Review of Drainage Proposals

Land South of Lymington Ridgeway Lane & Lower Pennington Lane

February 2021

2.4 Proposed Development

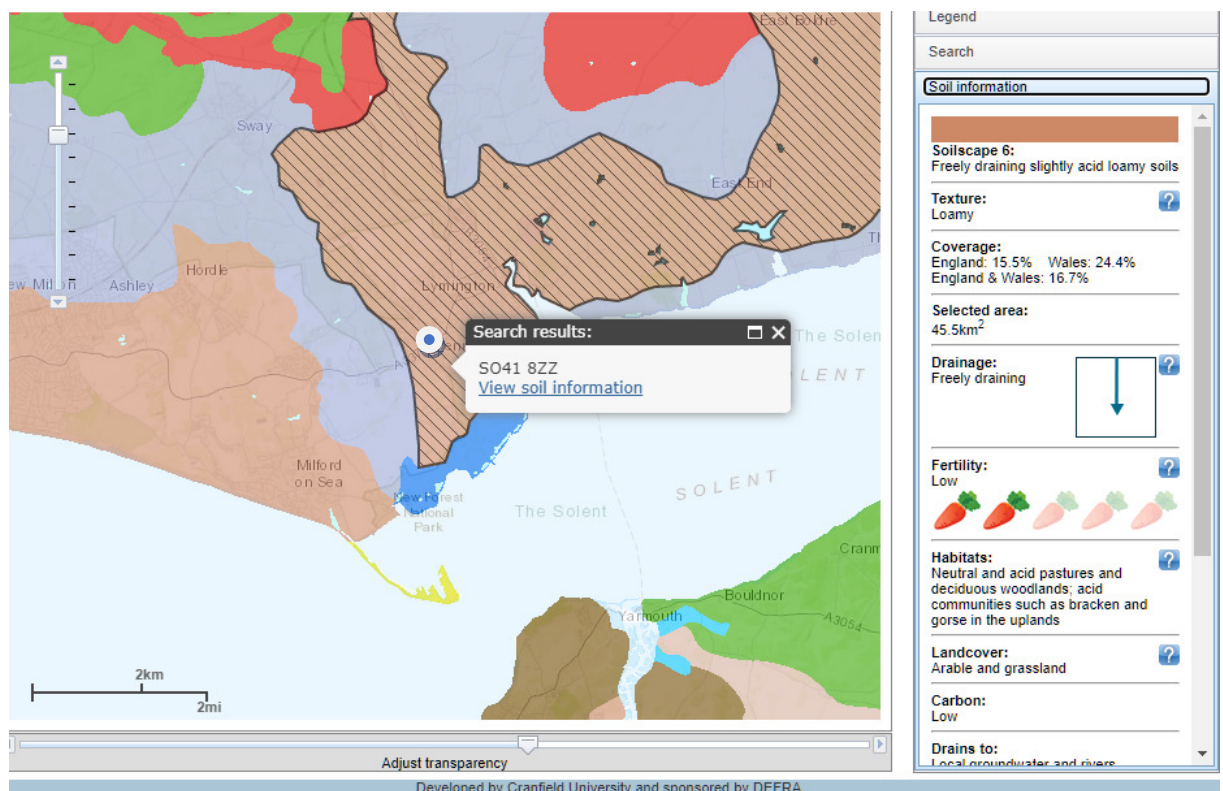
It is understood that the proposals are to construct circa 120 units.

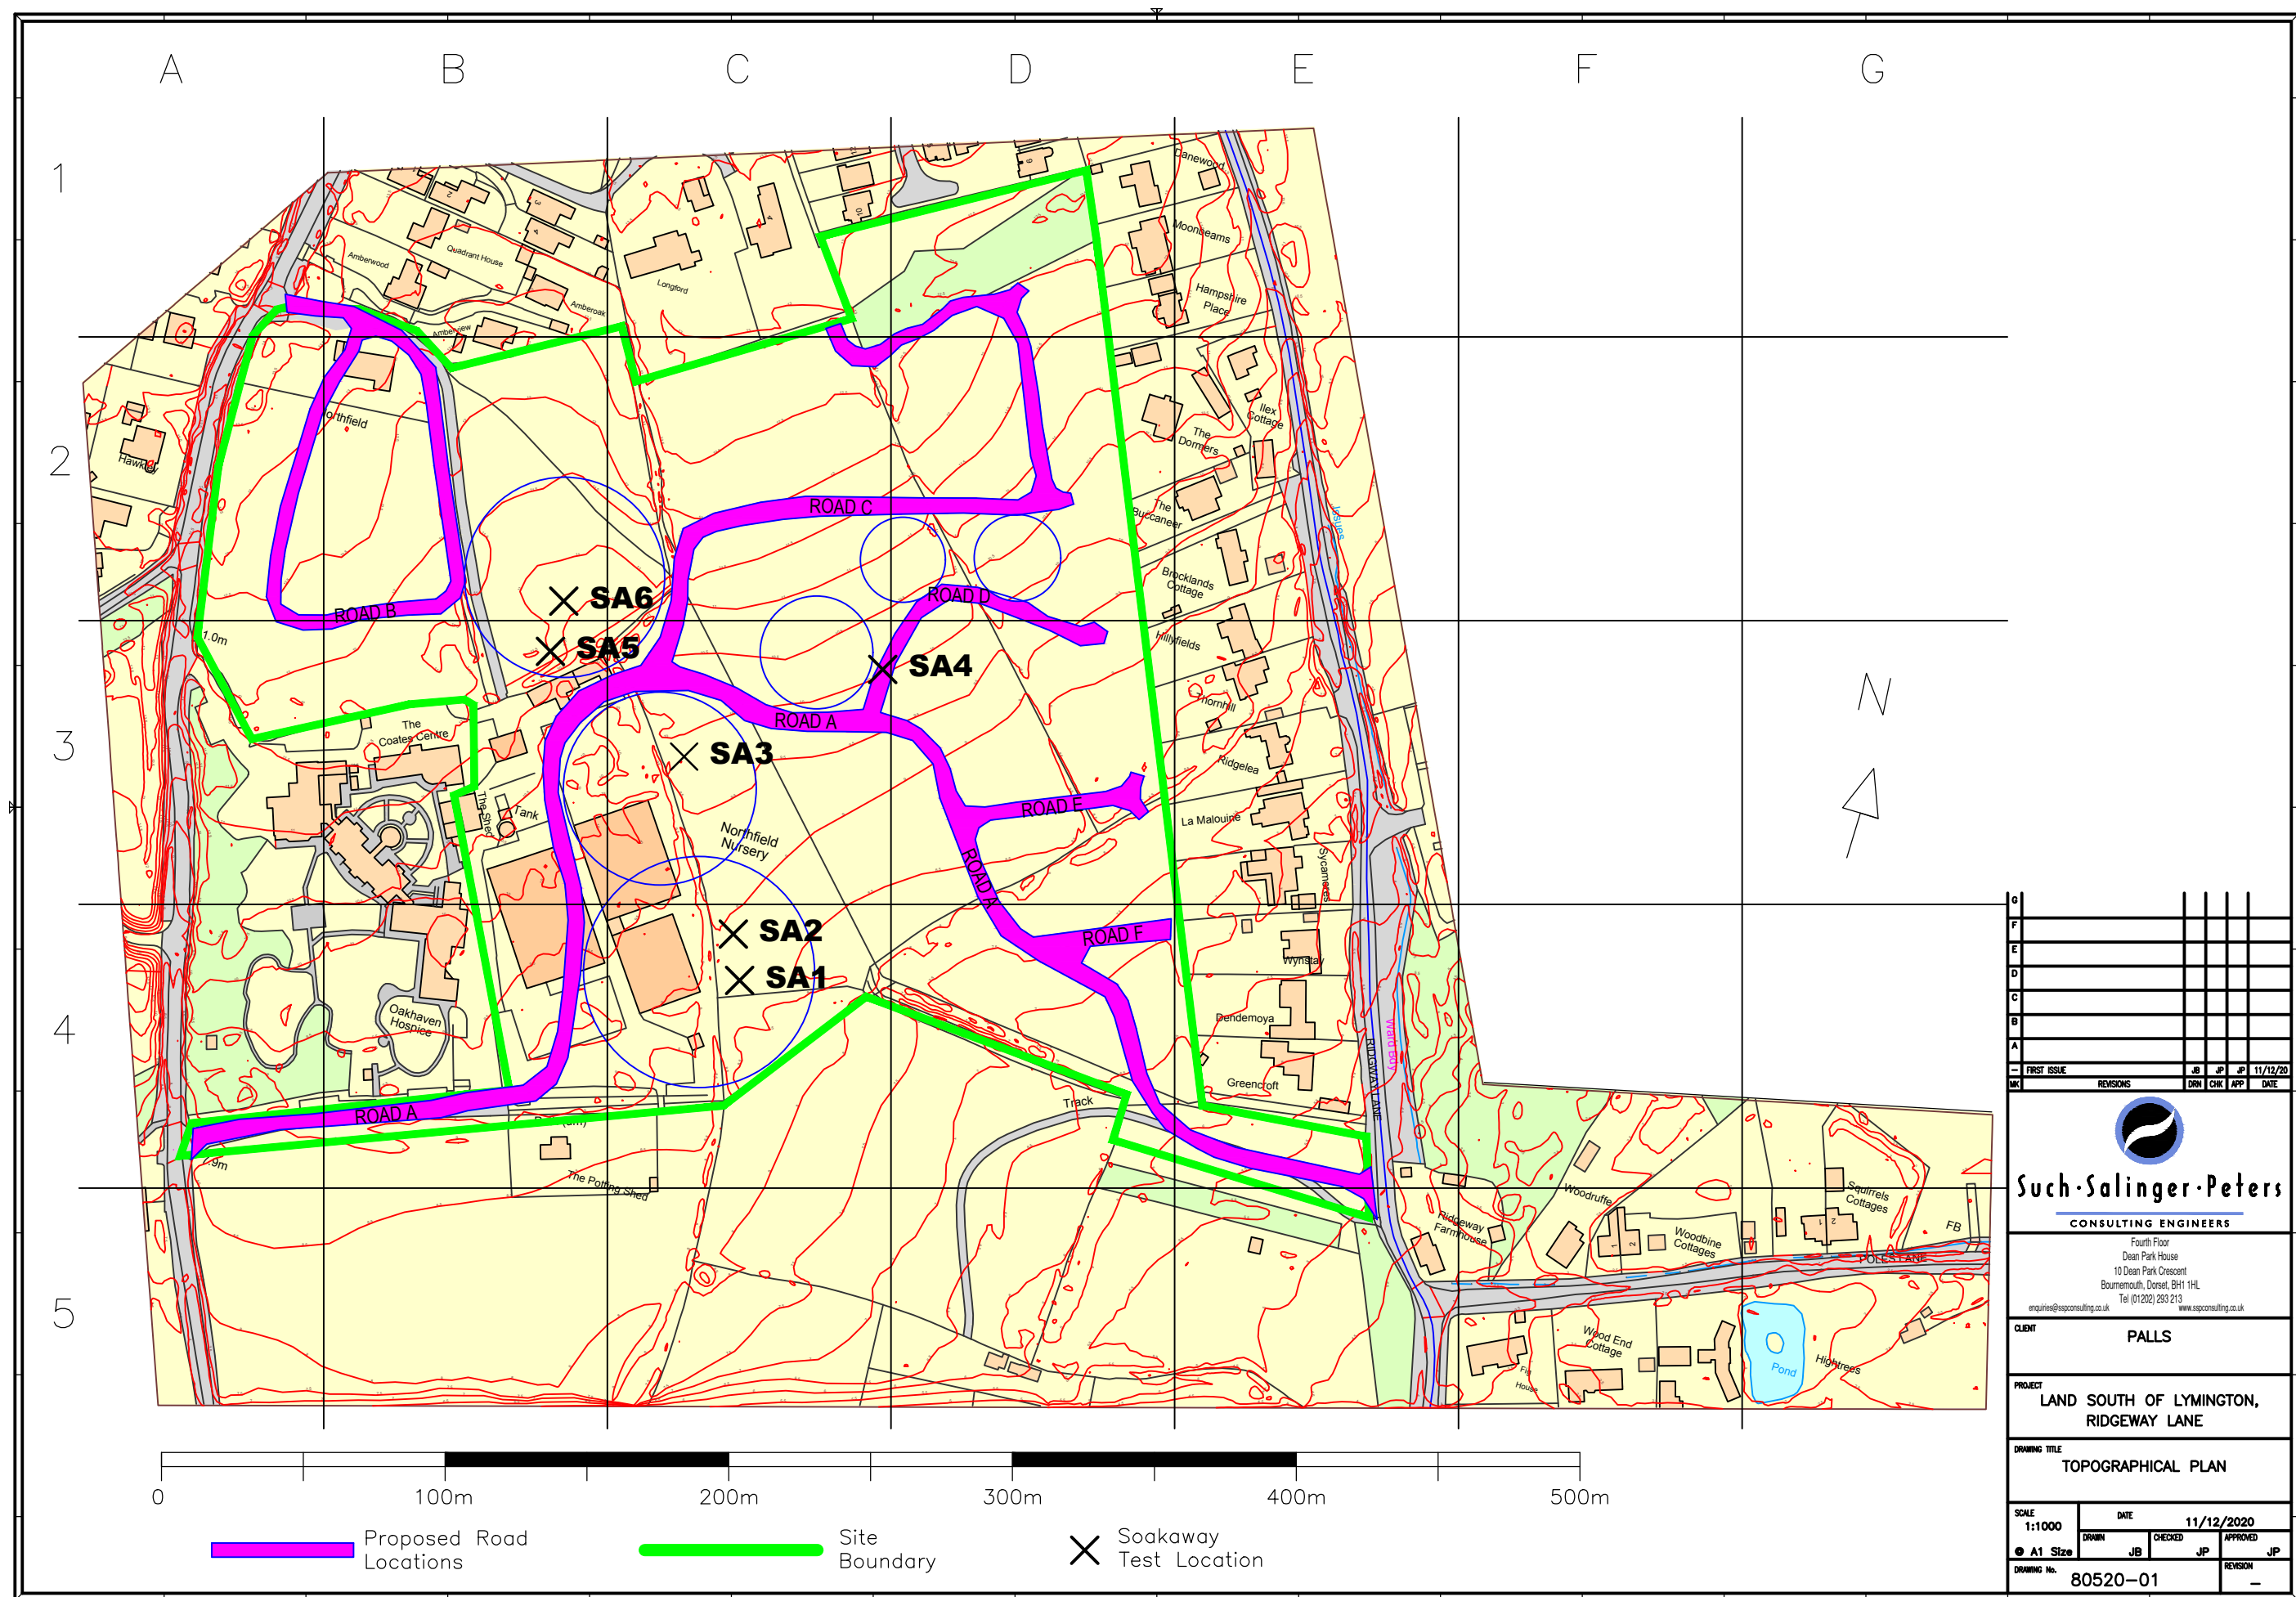
- 4.10 Should the eventual solution be to discharge into the ditch, appropriate attenuation would need to be installed to control the discharge into the ditch. The topography shown on Google Earth Pro shows that the land occupied by the properties to the east of Ridgeway Lane and directly north of Poles Lane are approximately 2.5 metres below the lowest point of the proposed site. This indicates that should the ditch flood, this area could become affected.

- 4.11 Whilst installing the appropriate attenuation would limit the discharge rate to the ditch system it is noted that the system is already prone to flooding as shown by the EA Flood Map and as such the entire ditch system downstream of the point of connection should be investigated. Evaluation using hydraulic modelling based on accurate topographic data would be considered a minimum level of investigation. It is known that currently after heavy/persistent rain the existing drainage flows lead to flooding in the vicinity of Creek Cottage, Lower Woodside and Maidens Lane and this situation must not be made worse by this proposed development.

- 4.12 With the recent change in legislation to encourage adoption of surface water attenuation by Water Companies, rather than to rely upon Management Companies to maintain such structures, full details of the proposed surface water discharge and attenuation structures must be agreed prior to Planning Permission being sought especially as any proposal will affect the positioning of the housing..
